RE: Humboldt Bay Generating Station Insignificant Project Change Request (06-AFC-07C)

Petition for Modification No. 1

Humboldt Bay Generating Station

Fields Landing Laydown Area

FIGURE 2
FIELDS LANDING LAYDOWN
LOCATION MAP
 HUMBOLDT BAY GENERATING STATION

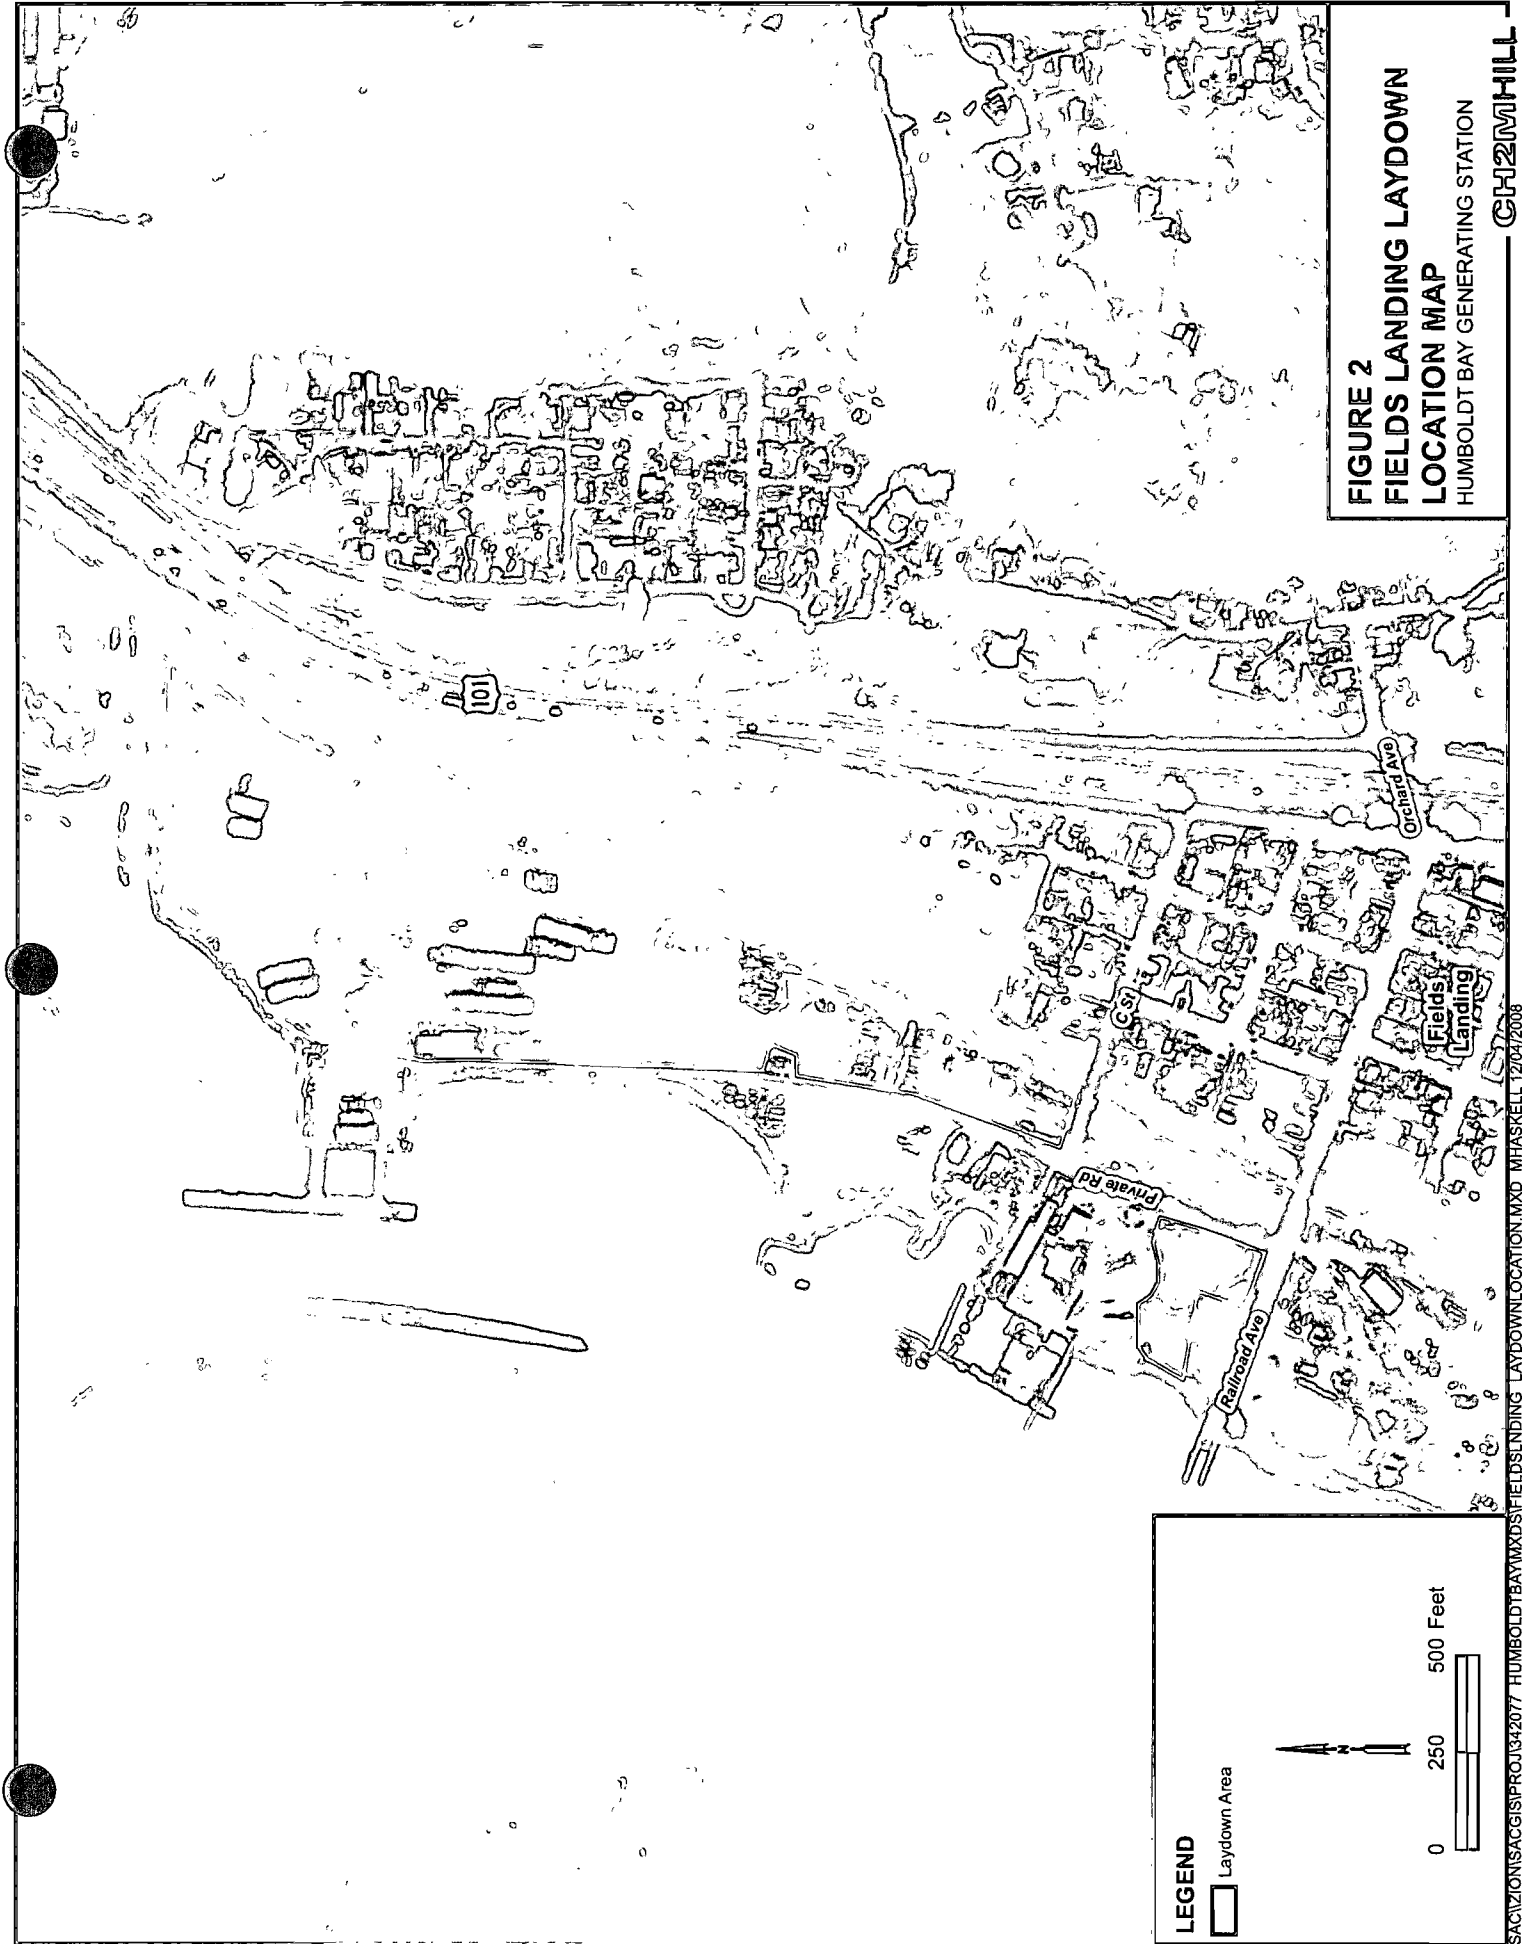
This section includes a description of the proposed project modifications, consistent with CEC Siting Regulations (Title 20, CCR, Section 1769 [a][1][A]). The HBGS project would use two additional laydown areas located in Fields Landing. Figure 1 shows the locations of the two proposed laydown areas relative to the HBGS site. Figure 2 shows the laydown area locations within Fields Landing.
